Subject: Response to Request for Additional Information (Modification 18 of the Port Botany Expansion (DA494-11-2003-i-Mod-18))

This letter provides a response to the Request for Additional information issued by the Department of Planning, Housing and Infrastructure on 27 November 2025. Modification 18 of the Port Botany Expansion (DA494-11-2003-i-Mod-18) seeks to update references to legislation, streamline operational conditions for improved efficiency, remove redundant conditions and amend the frequency and scope of compliance-based conditions.

Figure 1 Schedule 3 of the Consolidated Consent, depicting the Approved Stage 1 Port Footprint

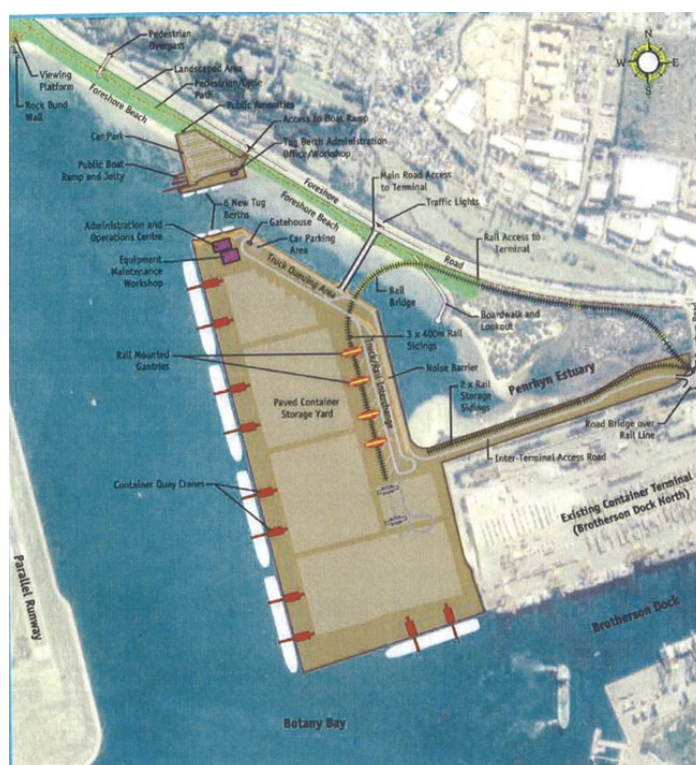
The request to remove / delete certain conditions may have unintended effects to the future development of land that is vacant / undeveloped or infrastructure that has yet to be constructed (i.e. rail access by means of an extension of the existing Botany Freight Rail Line parallel to Foreshore Road including a rail bridge and culverts).

1. *of the intended future use of any undeveloped land and how this will be managed*
2. *the status of the approved Rail Line parallel to Foreshore Road, including a rail bridge and culverts, as shown in schedule 3 of the consent i.e. will this rail infrastructure be constructed in the future, and likely construction timeframe.*

Regarding the Rail Line parallel to Foreshore Road and associated infrastructure depicted in Schedule 3 of the Consolidated Consent (see Figure 1), as well as described in Condition A2.1, it is noted that this depiction / description of the approved development is outdated. Schedule 3 and Condition A2.1 were included in the original approval (issued 13 October 2005), which approved a rail layout that can be seen in Figure 2. However, the application has subsequently been modified, which has resulted in a number of changes to the approved development.

Modification 7, approved on 20 March 2009, modified the approved rail configuration to allow the then Sydney Ports Corporation to pursue either the originally approved rail configuration or an Alternate Rail Configuration along the Inter-Terminal Road Access Corridor (Figure 3). The Alternative Rail Configuration was ultimately pursued and subsequently completed. As such, there is no intention or ability to construct the originally approved rail siding parallel to Foreshore Road, as this element is effectively no longer included in the approved design.
